ADDENDA FOR MONITOR MANUAL - June 2010 (continued)

INSTALLING THE PENDULUM SHEET LINES (Section 3.5)

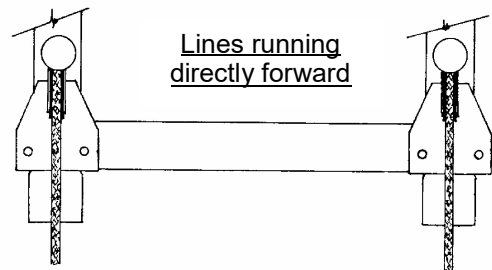
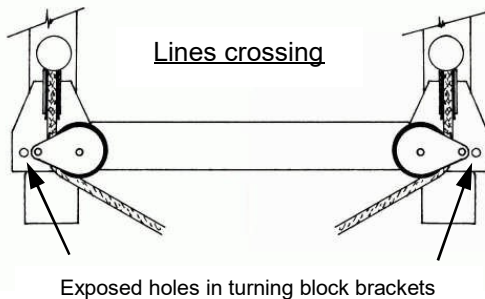
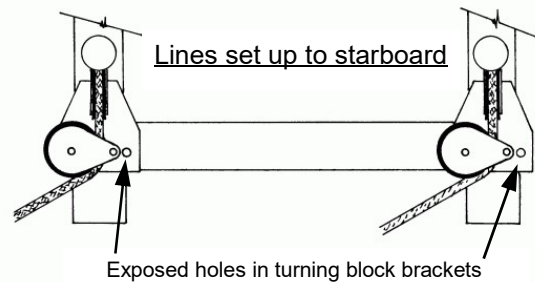
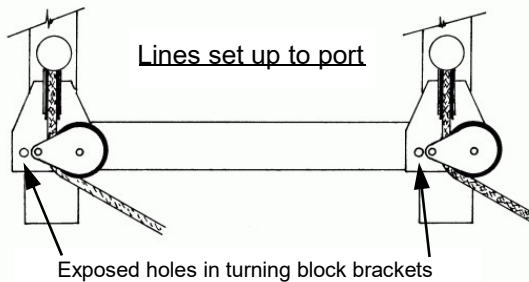
Note that new Monitors are shipped with their turning blocks set up to lead the lines to port for a wheel-equipped boat, and with the lines crossing for a tiller-equipped boat. If you are shifting a Monitor from one boat to the other, switch the turning blocks to match the new installation. Note that wheel-equipped boats can have the lines set up both to port, both to starboard, or one on each side, as preferred. Tiller-equipped boats must have the lines crossing to opposite sides - see instructions. When moving the turning blocks, set up their mounting bolts so the lines have a straight run from the interior blocks to the turning blocks, without an offset 'jog' which will cause binding and chafe.
